Tomingley Gold Mine Submissions Report

Project Approval No. 09_0155

Modification 4

Figure 1 presents the approved site layout, including water management structures.

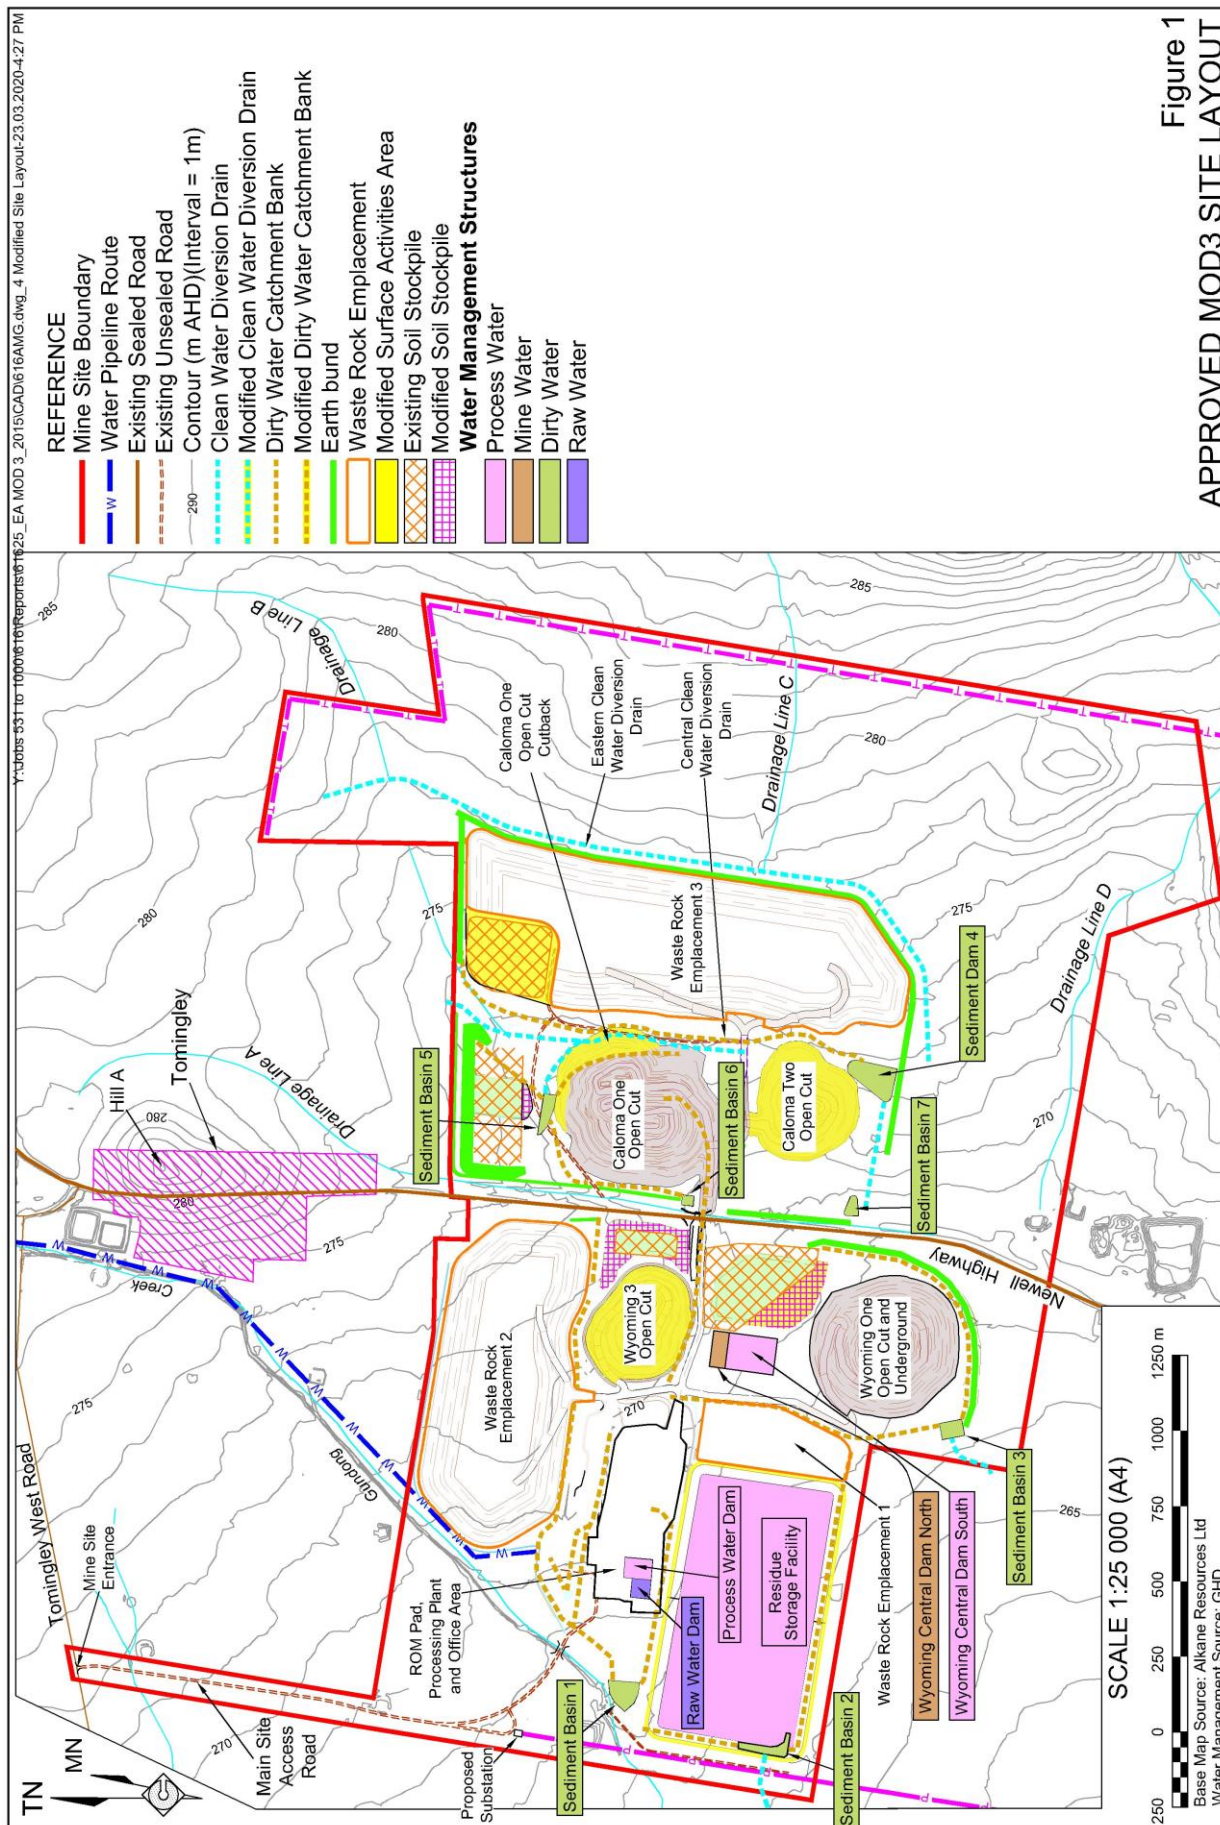
Please provide an updated Figure 2 of the Modification Report to reflect all the currently approved infrastructures, and include all the surface water structures (for both processed water and mine water)

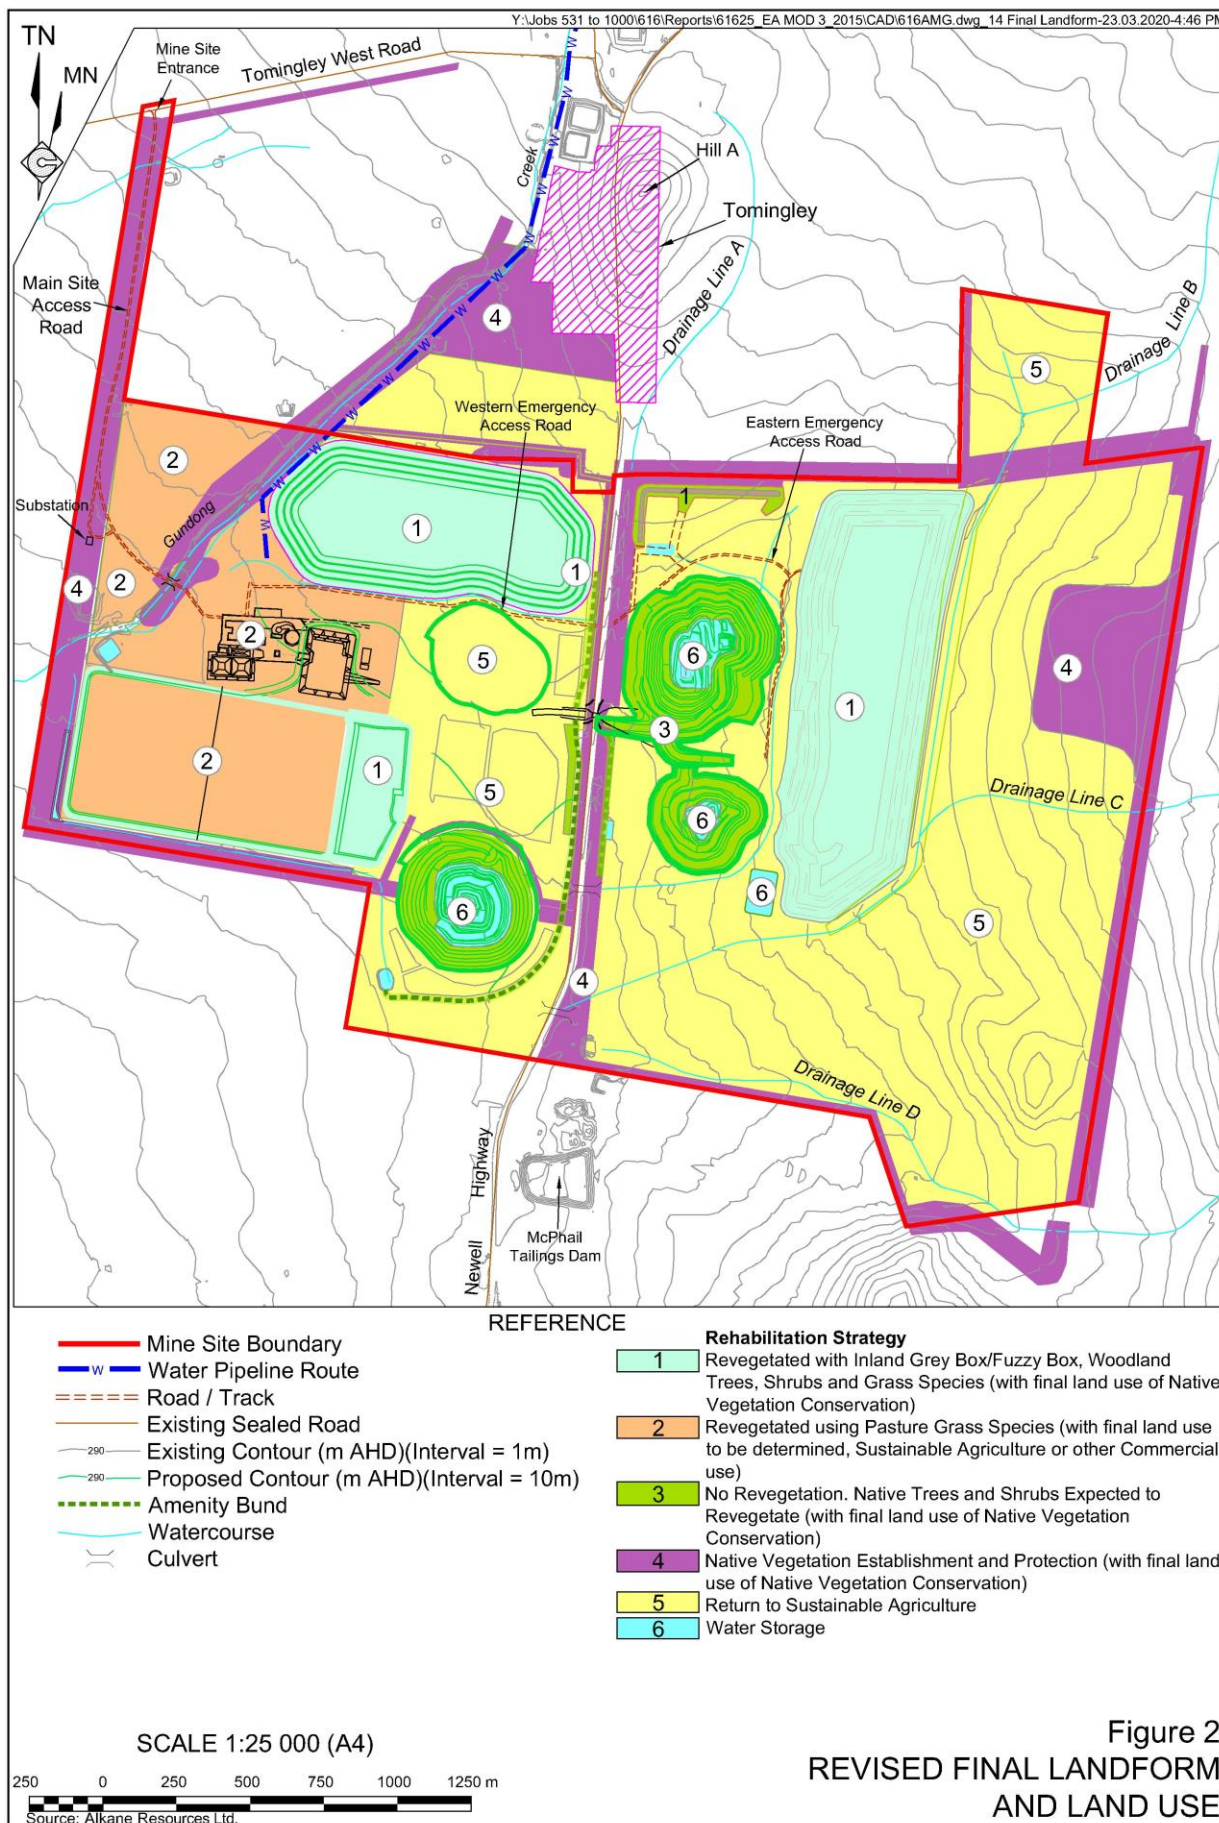
Please confirm if the rehabilitation plan map included in the project approval is still current.

Appendix 6 of PA 09_0155 displays the approved indicative final landform and land use following rehabilitation of the Mine Site. The rehabilitation strategy outlined in this plan remains current. **Figure 2** presents a revised version of this plan taking into account the slightly increased footprint of the Residue Storage Facility.
